Service Bulletin

NOISE FROM REAR DIFFERENTIAL MOUNT(S)
Last Issued: 10/14/2015

Bulletin No: 03-007/15	Last Issued: 10/14/2015
© 2015 Mazda Motor of America, Inc.

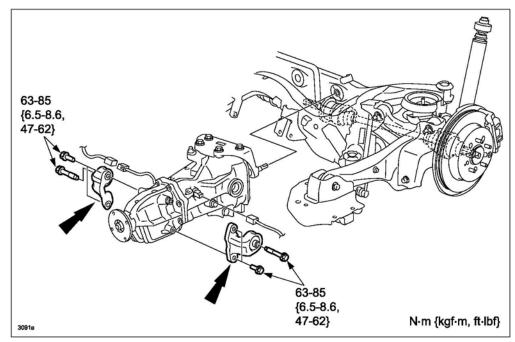
Some vehicles may experience vibration during acceleration and/or noise coming from the rear of the vehicle.

Due to environmental heat and heat from the exhaust system, the rear differential mounting rubber may become hardened and cracked, resulting in vibration and/or noise.

To eliminate this concern, the rubber material has been improved.

3. Replace the mounting rubber(s) with a modified one according to the instructions on MS3 online or the Workshop Manual (section 03-14 REAR DIFFERENTIAL REMOVAL/INSTALLATION).
